METROPOLITAN GOVERNMENT OF NASHVILLE AND DAVIDSON COUNTY

STAFF RECOMMENDATION
3916 Cambridge Avenue
March 17, 2021

Application: Demolition—Outbuilding; New Construction—Addition; Setback determination

Applicant: Dave Purser, Purser Architecture & Design

Figures 2 & 3 show the existing garage on the lot that is proposed to be demolished.

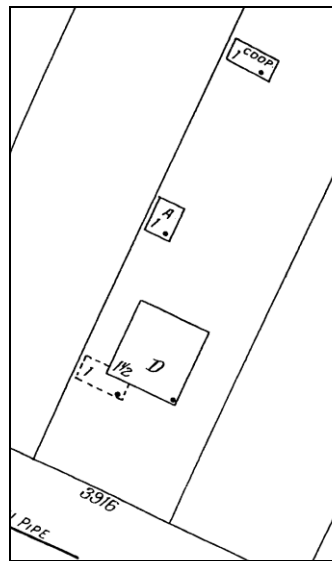
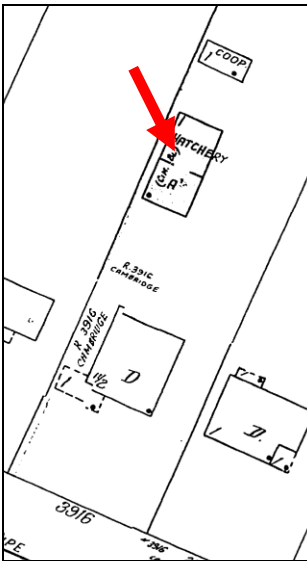
Demolition: There is an existing garage on the lot which is proposed to be demolished (Figures 2 & 3). The garage's date of construction is not known. It could be the same structure that is seen in the 1951 Sanborn Map, although it is not seen in the 1930-31 Sanborn Map (Figures 4 & 5).

Even if the existing garage is the same as the structure seen on the 1951 Sanborn map, staff finds that the garage is not architecturally or historically significant to the site. It does not contribute to the historic character of the house or the overall neighborhood.

Staff therefore finds that the demolition of the garage to meet Section III.B.2 for appropriate demolition.

Sheet Title & Number:
Arch. Site Plan

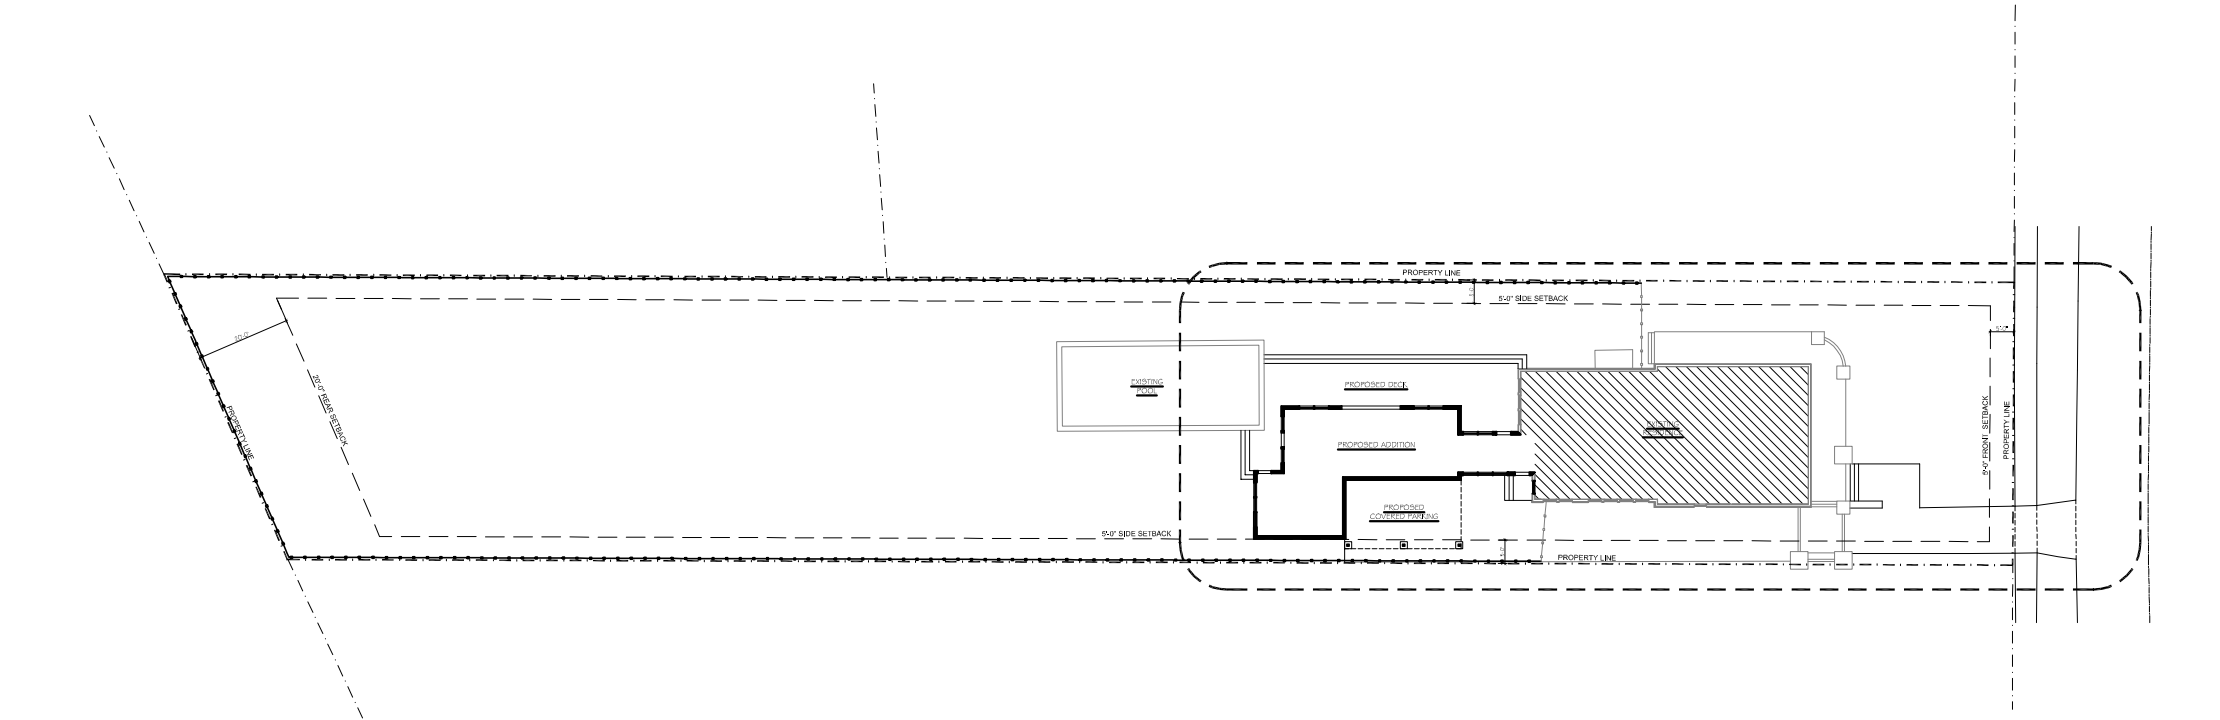
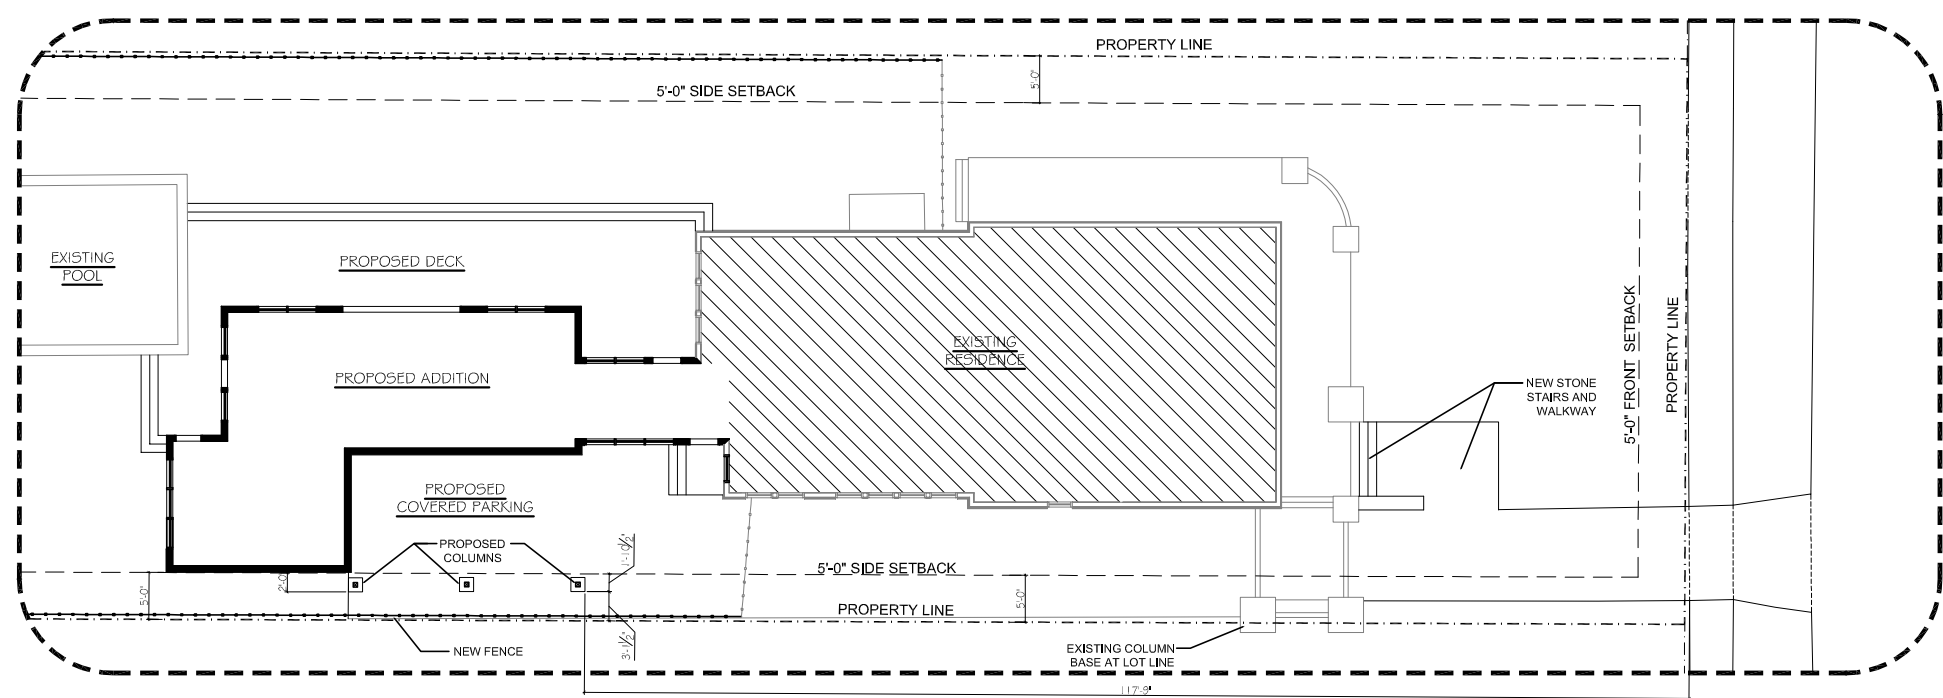
Setback & Rhythm of Spacing: The addition meets the right and the rear setbacks. It will be over be approximately twenty-eight feet (28') from the right-side property line and over two hundred feet (200') from the rear property line. The addition requires a setback determination on the left side. Base zoning requires a five-foot setback, but a portion of the building will be approximately three feet, one inch (3'1") from the side property lines. Although the house has a porte cochere at the front that does not meet the five foot (5') side setback, staff finds that the extending into the side setback does not meet the design guidelines The lot is very deep so there is ample opportunity to extend an addition and/or a detached garage into the rear of the property without the need to encroach into the left-side setback.

Staff finds that the proposed left side setback does not meet Sections II.B.1.c. and II.B.2. of the design guidelines.

Sheet Title & Number:
 Exterior Elevations

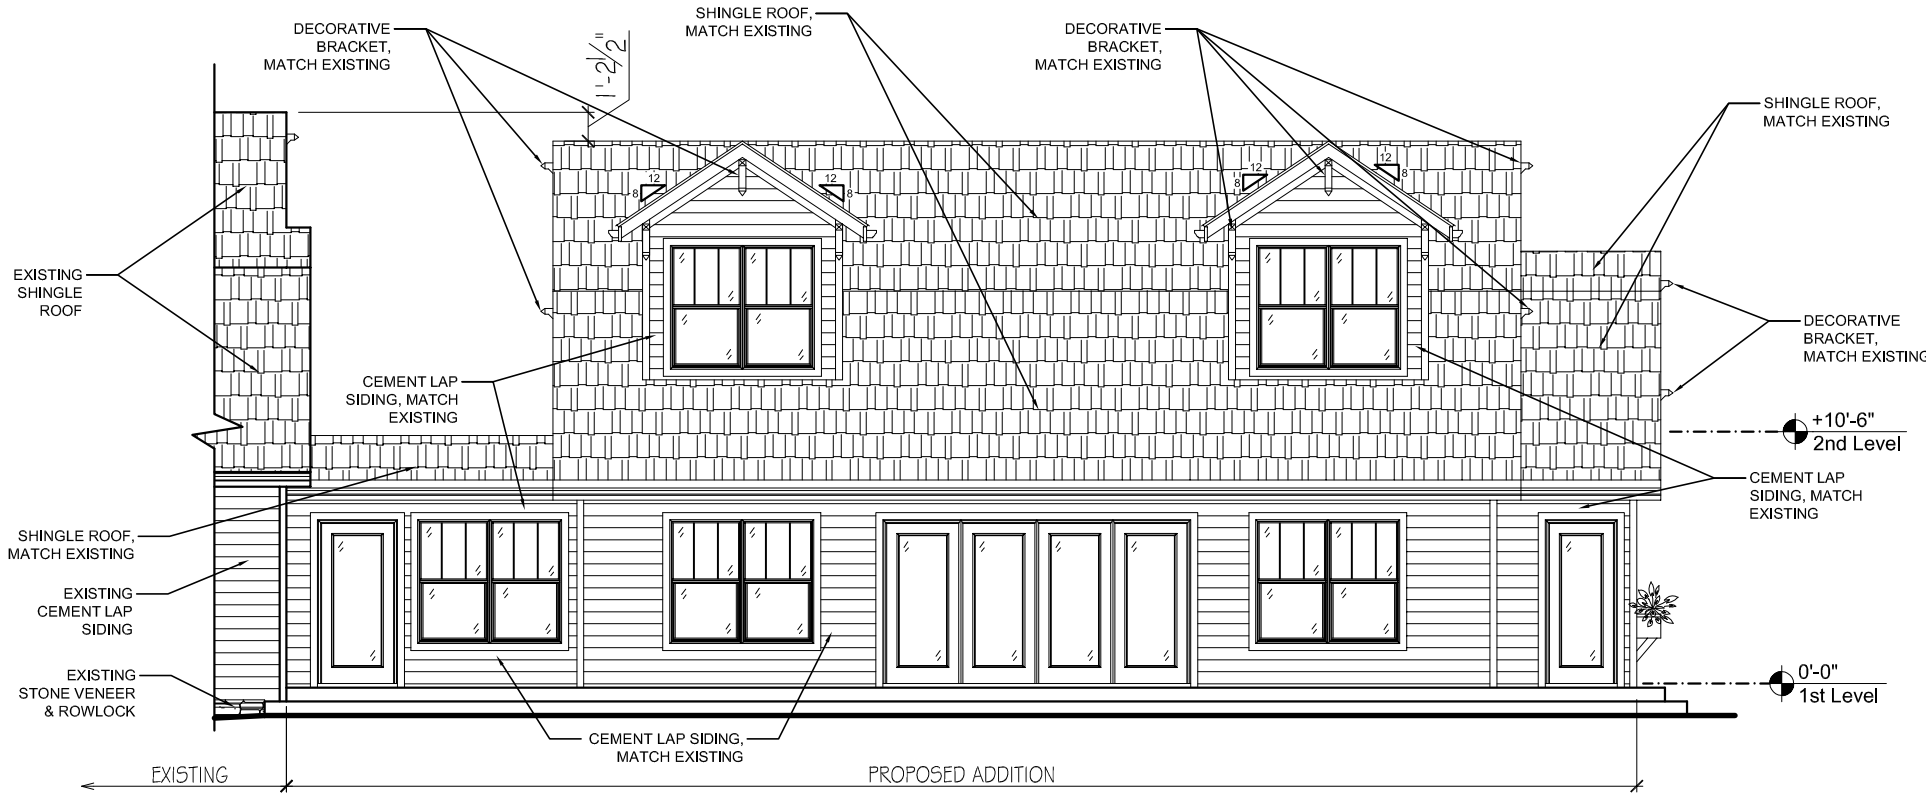
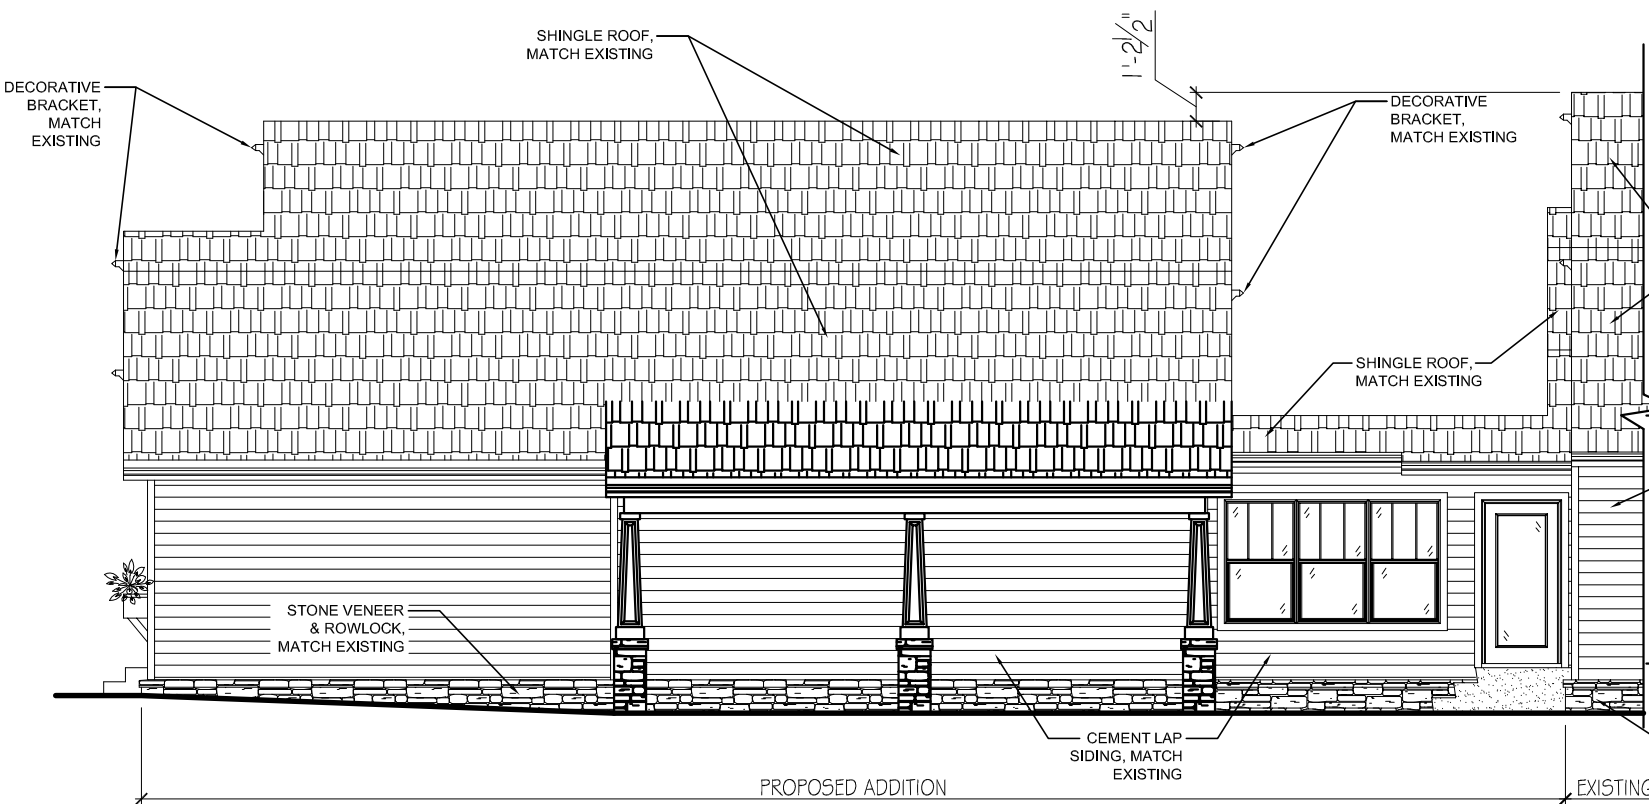
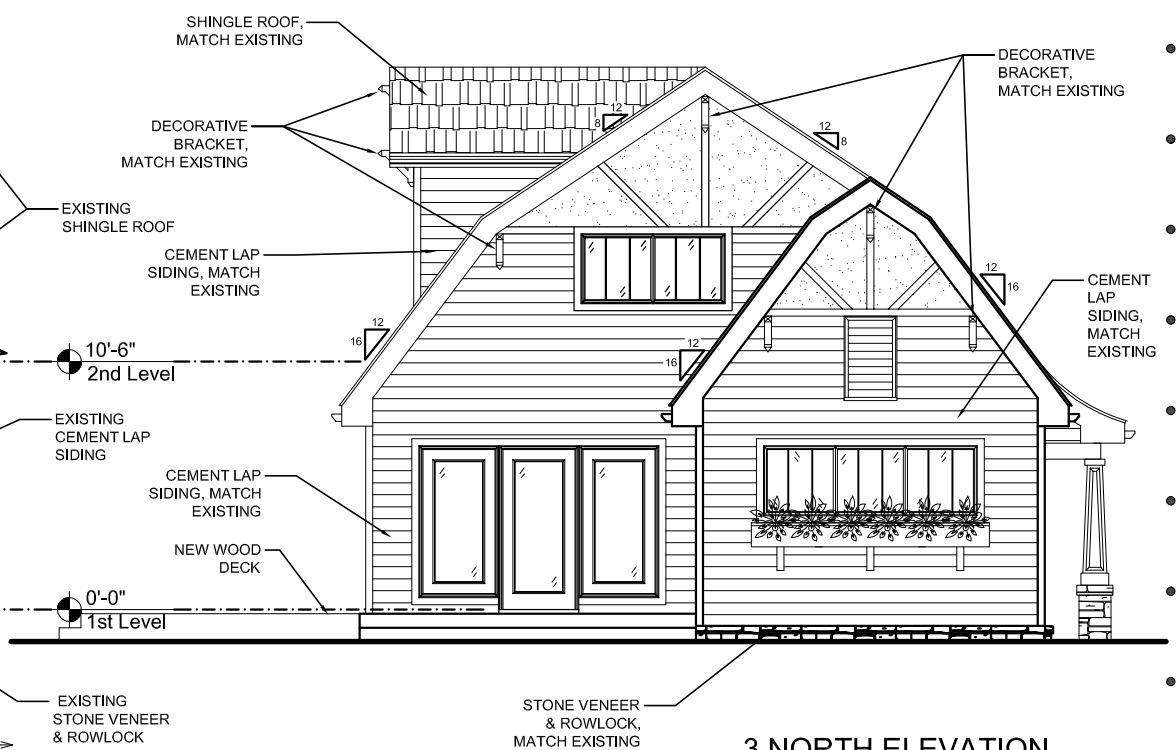
Roof form: The historic house and the 2005 addition have gambrel roof forms. The proposed addition ties into the house with a one-story 3/12 gable connector. The main form of the addition will be a front facing gambrel roof with slopes similar to those on the historic house. The right-side facade includes 8/12 gabled dormers that are inset at least two feet (2') from the wall below. Staff finds that these roof forms are compatible with the roof forms of the historic house.

Proportion and Rhythm of Openings: No changes to the window and door openings on the existing house were indicated on the plans. The windows on the proposed addition are all generally twice as tall as they are wide, thereby meeting the historic proportions of openings. The left façade does not have any window openings. However, this wall is over one hundred and fifty feet (150') back from the front property line and will not be highly visible from the street. The paired triple window openings do not have four to six-inch (4"-6") mullions in between them, as is typically required. If the Commission approves the addition, staff recommends that all double and triple window openings have a four to six-inch (6") mullion in between them.

With the condition that all double and triple window openings have a four to six-inch (6") mullion in between them, Staff finds the project's proportion and rhythm of openings to meet Sections II.B.1.g. and II.B.2. of the design guidelines.
